## V2500-A1/A5 SERIES NACELLE SERVICE BULLETIN

This document transmits Revision 1 to Service Bulletin NV2500-78-0199

# V2500-NAC-78-0199

NACELLE – THRUST REVERSER – AFT SUPPORT RING REPLACEMENT – BLANK CASCADE REPLACEMENT  
– ACTUATOR COVER REPLACEMENT

Replace the Blank Cascades – Eng No.1, LH Side  
Figure 3 (Sheet 1)

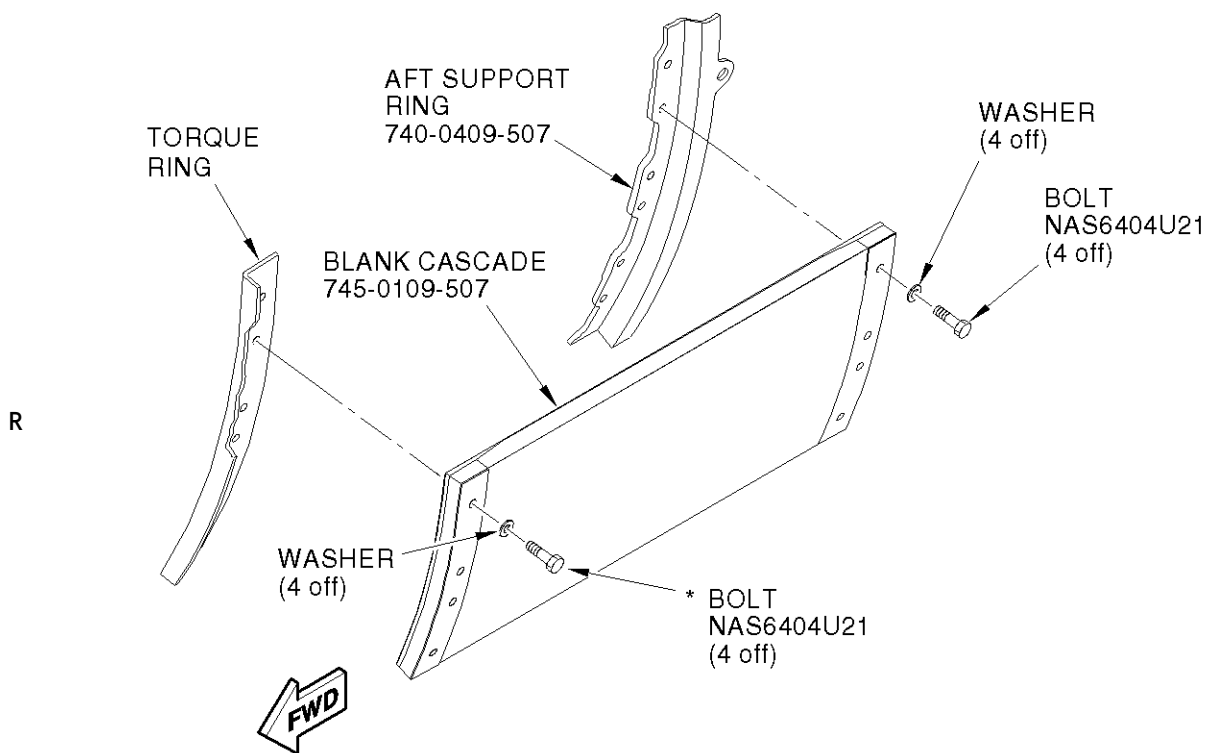
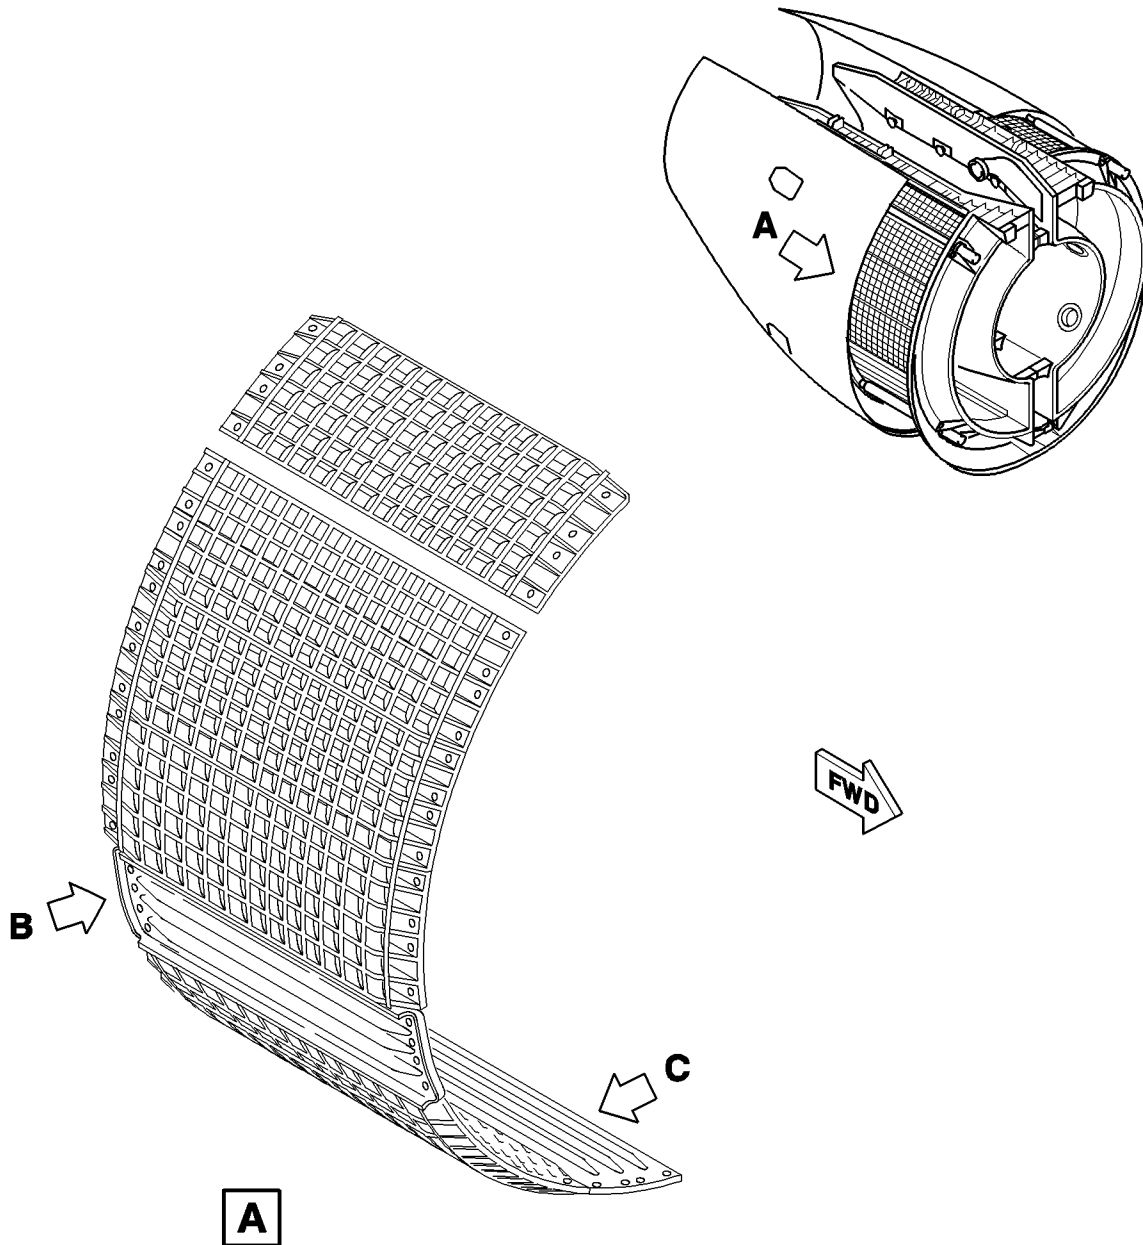
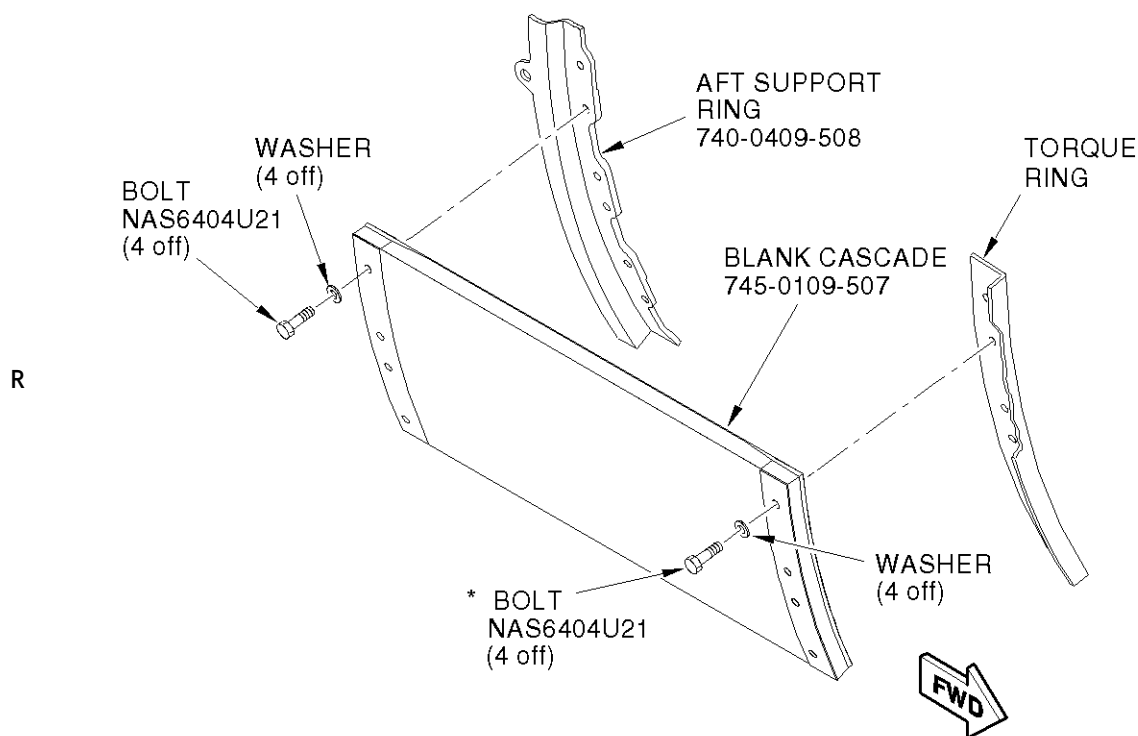
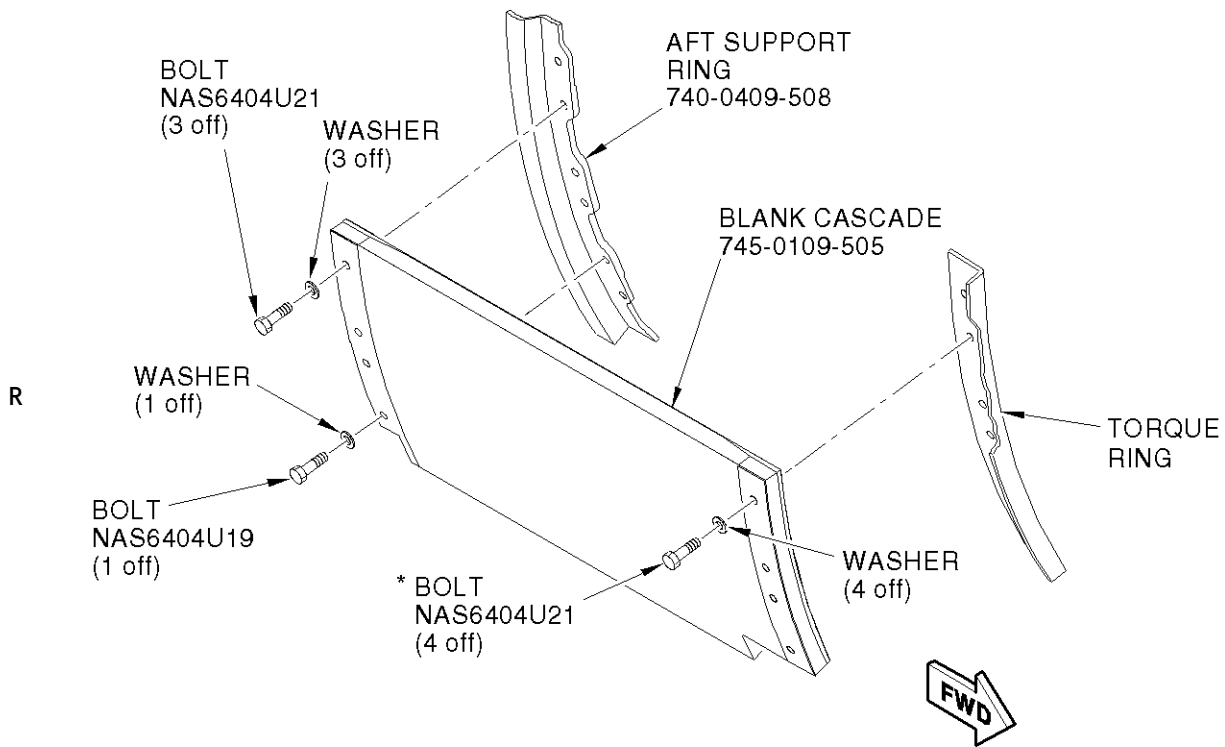
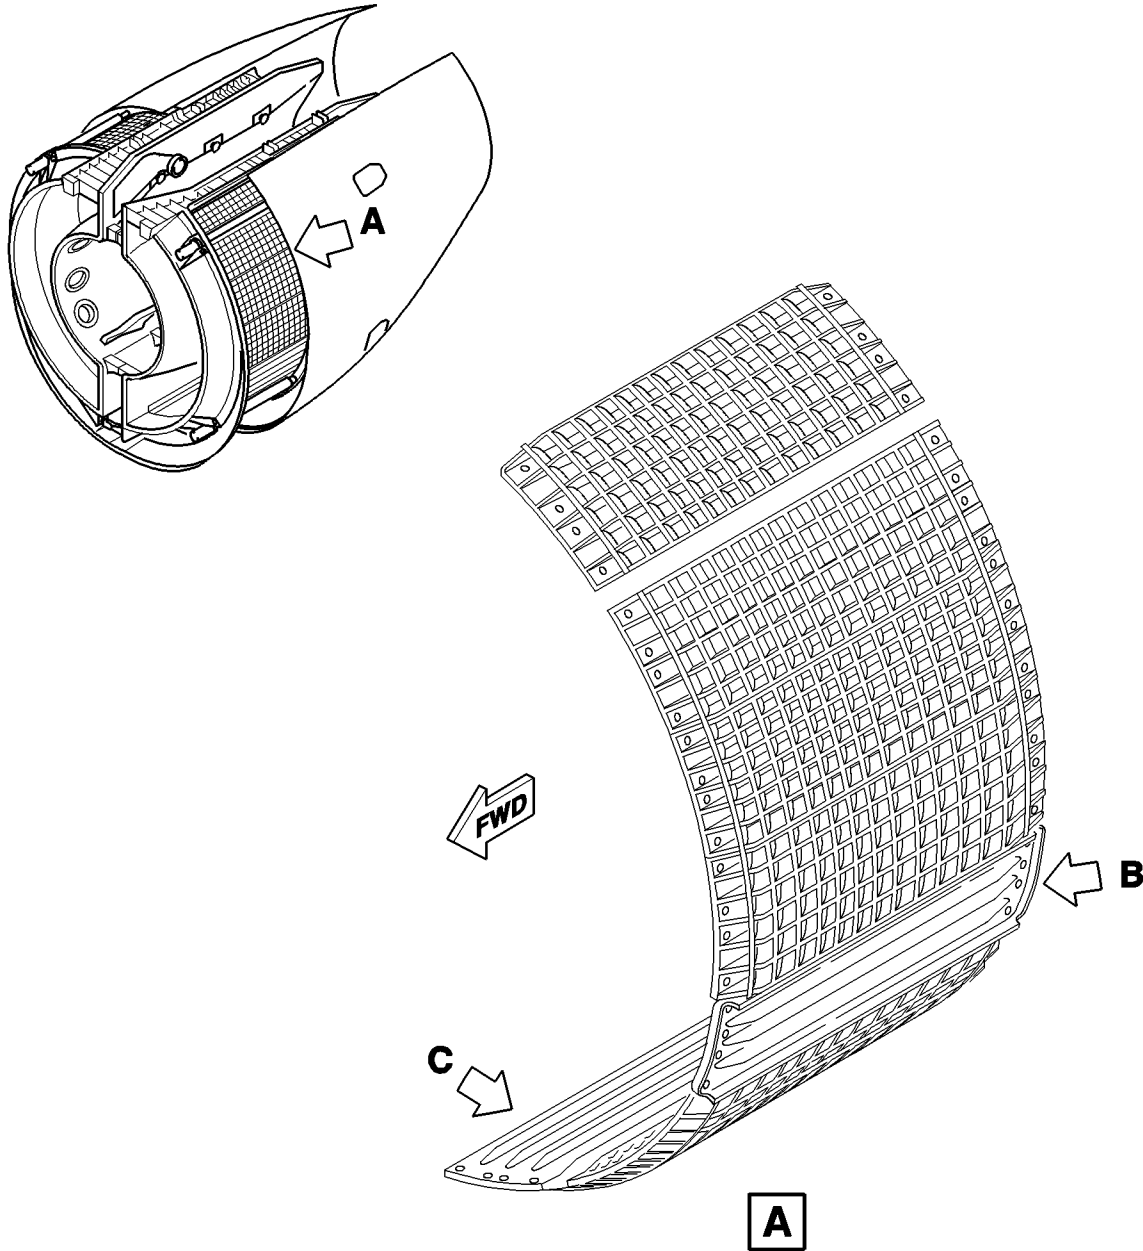
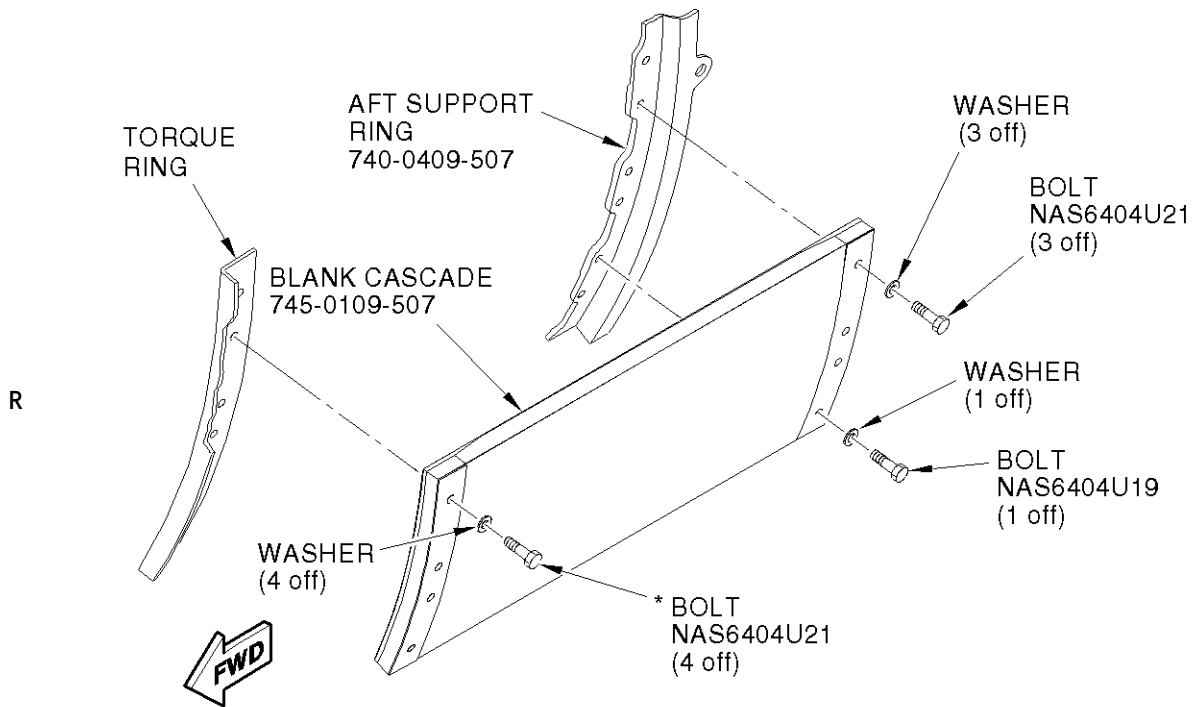
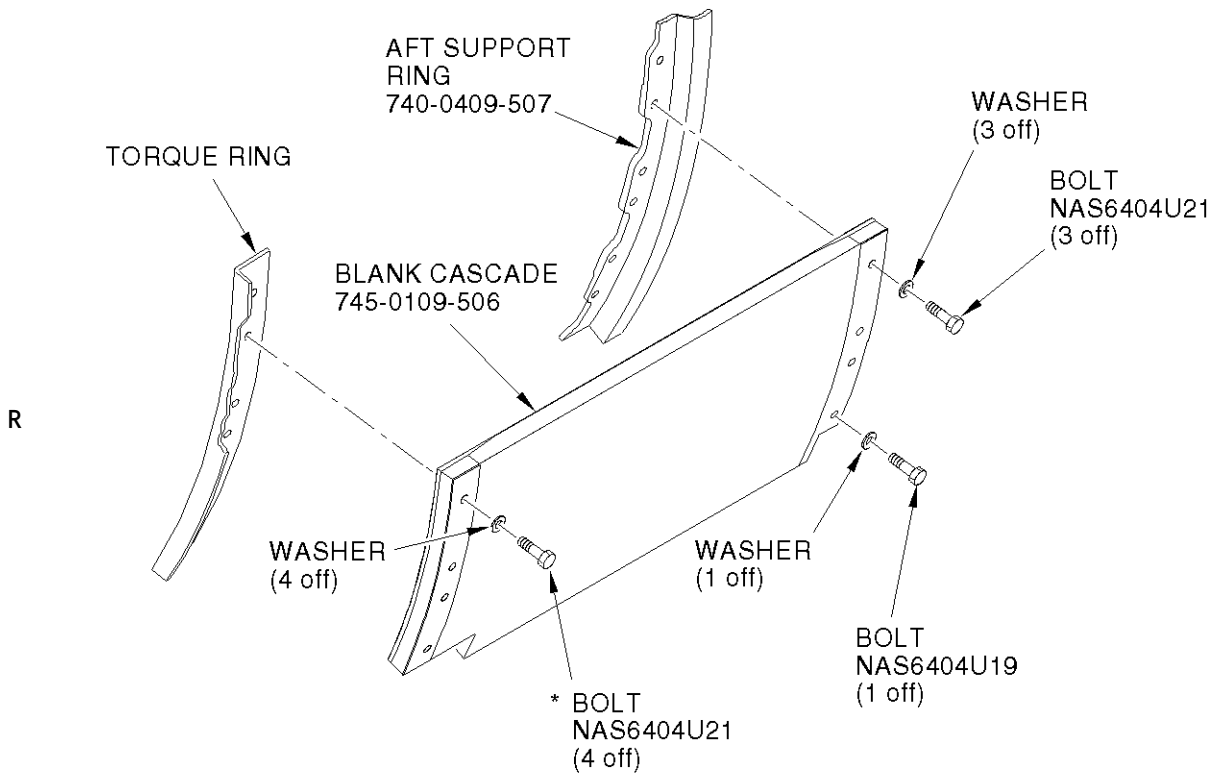
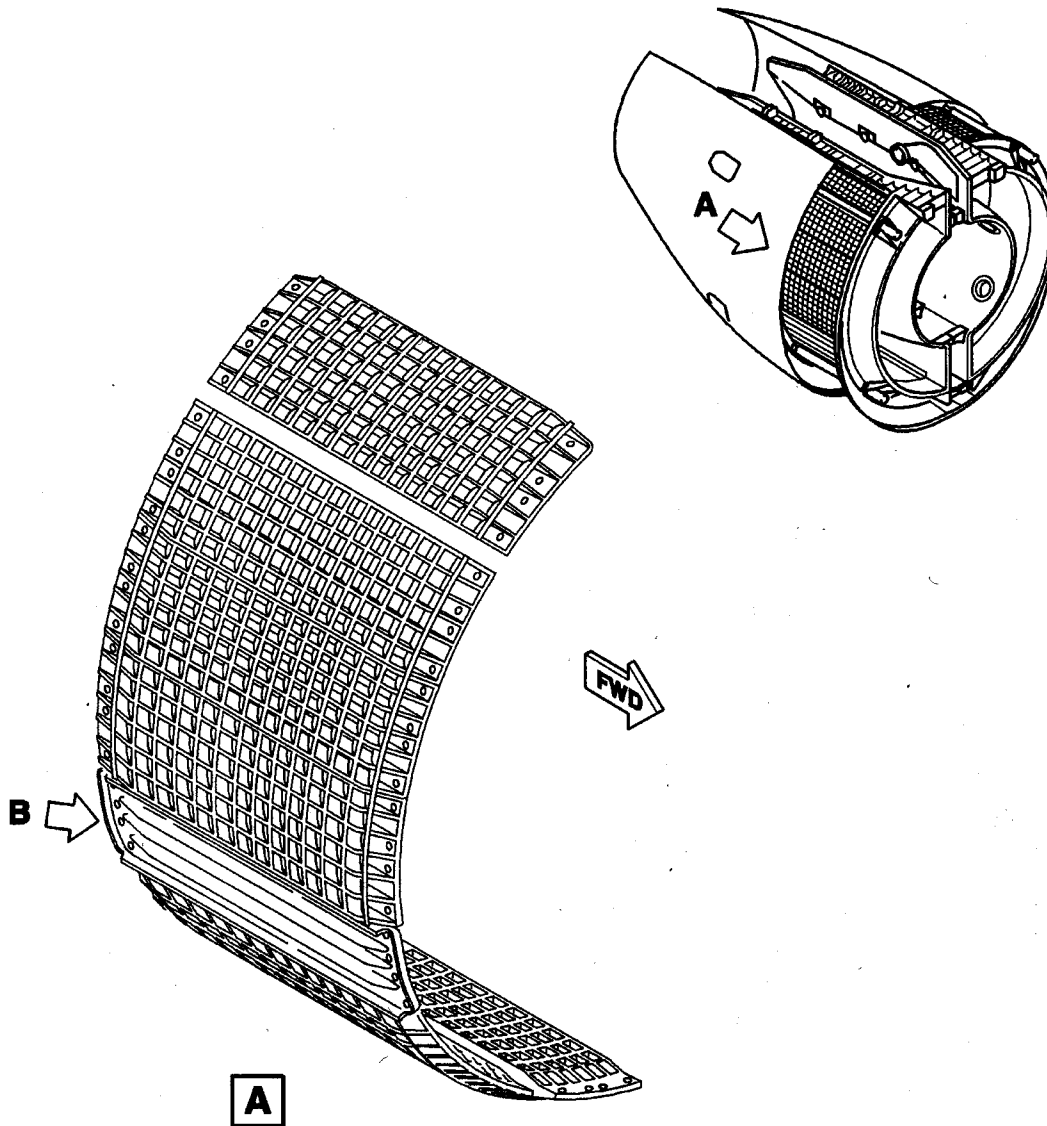
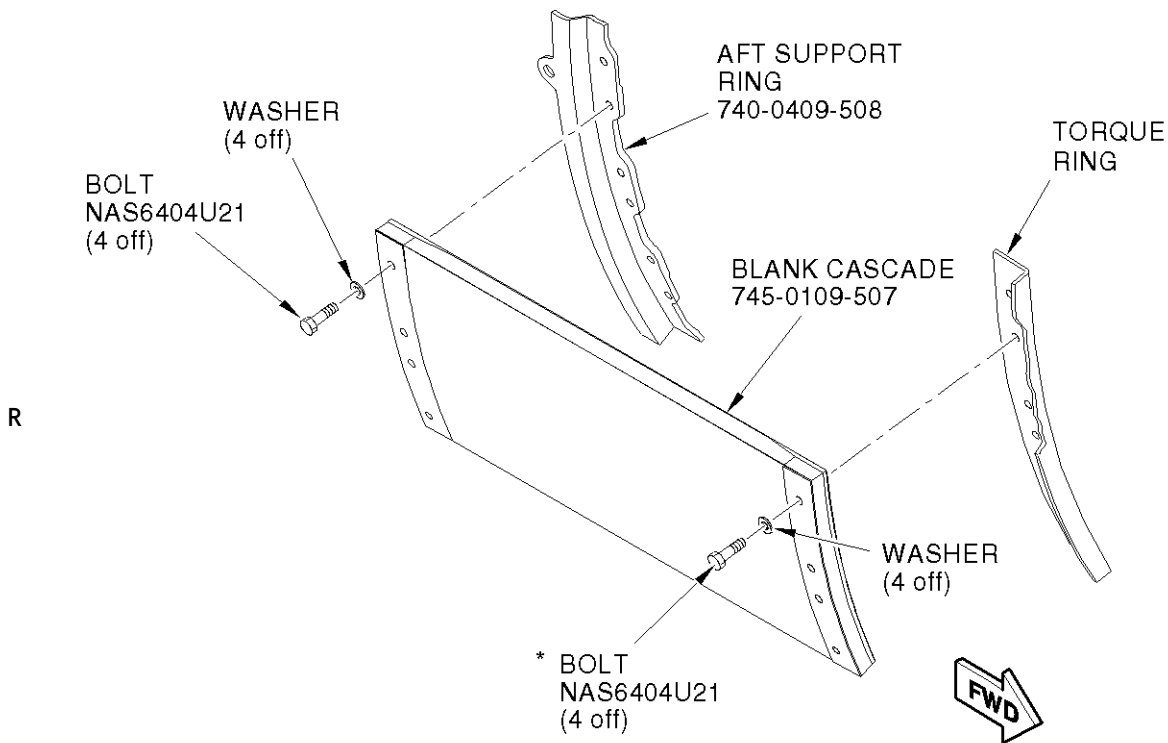
- R (14) Replace the blank cascades. Refer to Figure 3. Install the new blank  
R cascades. Refer to the Aircraft Maintenance Manual, TASK 78-32-19-400-010.

- R NOTE: The attach hardware for installation of a blank cascade on the new  
R aft support ring is different from that required for installation  
R on the old aft support ring. Refer to Figure 3 for the proper  
R attach hardware.
